SUNDRY NOTICES AND REPORTS ON WELLS
**Do not use this form for proposals to drill or to re-enter an
abandoned well. Use Form 3160-3 (APD) for such proposals.**

TELEDYNE 12 FEDERAL #1

API #30-015-33930 UNIT M Sec 12 T23S R28E 990/S & 990/W

Teledyne 12 Federal 1
30-015-33930
Vanguard Permian LLC
May 09, 2014
Conditions of Approval

Teledyne 12-2 Fed #1
Herradura Bend Delaware, East- 30-015-33930
Eddy County, New Mexico
PROPOSED COMPLETION - 1/2014

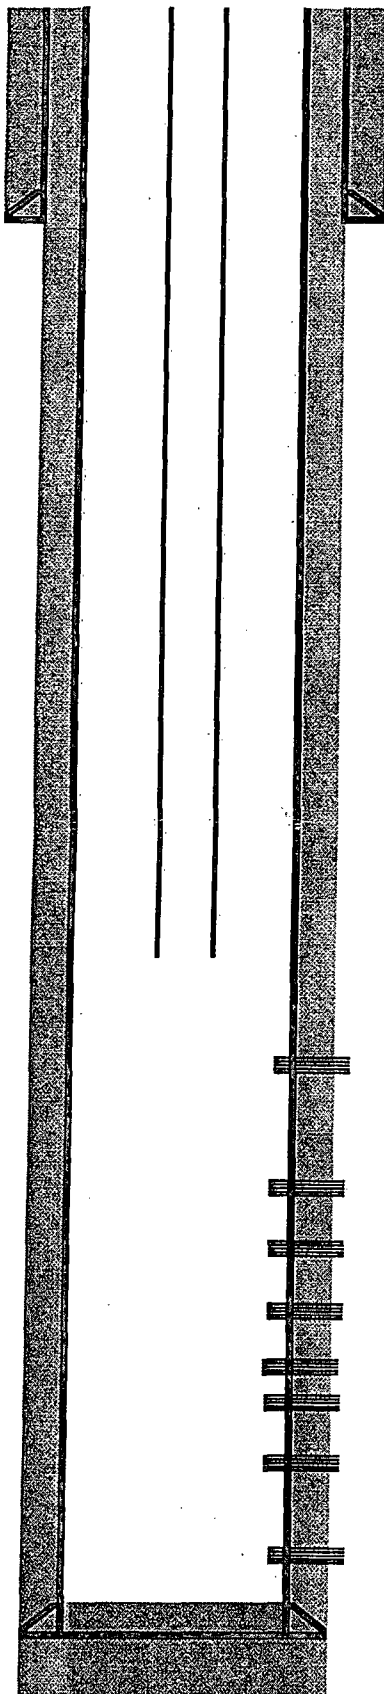
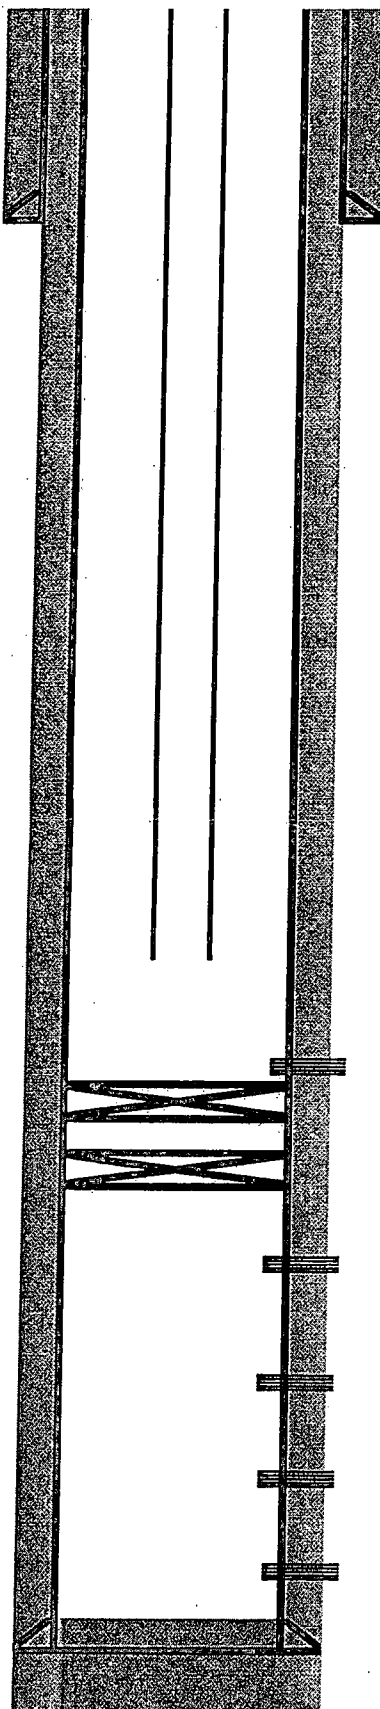
- 1. Operator is approved to drill out the CIBPs at 4,781' and 4,815'.**
- 2. Must conduct a casing integrity test before perforating and fracturing. Submit results to BLM. The CIT is to be performed on the production casing to max treating pressure. Notify BLM if test fails.**
